Re: 814 West Historic Mitchell Street

This is in response to your Staff Report dated 5/6/2019. This is our appeal to the decision made regarding the faced renovation.

2 PROPOSED WEST ELEVATION REVISION
 SCALE: 1/4" = 1'-0"

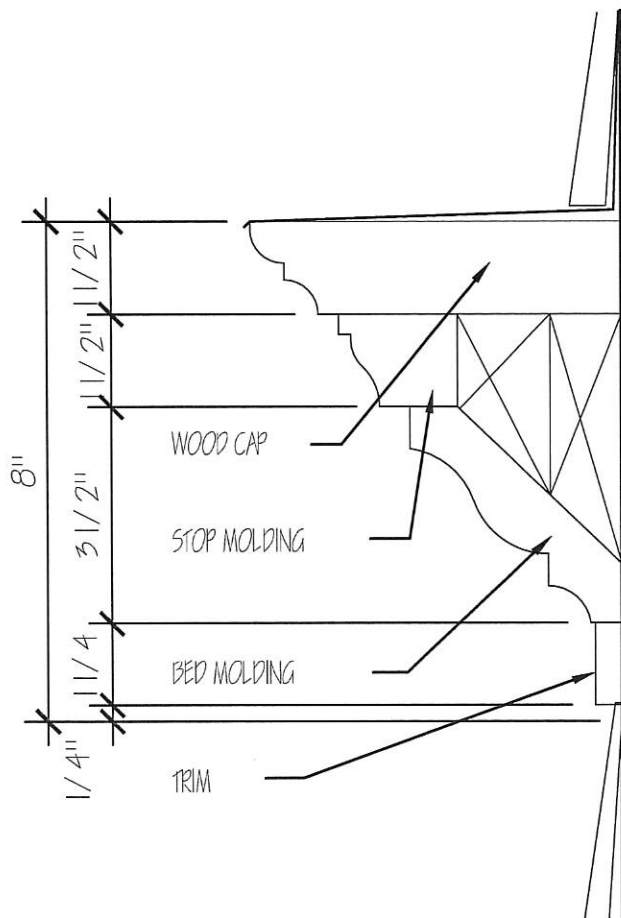
What is installed does not meet the approved drawings. We are proposing the removal of the horizontal push bar and period correct muntins, mullions and/or panels be adhered to the door to provide an appropriate period look.

We propose to continue the trim work that runs along the underside of the second story window all the way to the East end of the facade as originally shown on the drawings.

We are proposing a period correct architrave or cornice above the windows. This architrave/cornice would run from the West wall to the edge of the East vertical wood trim plank.
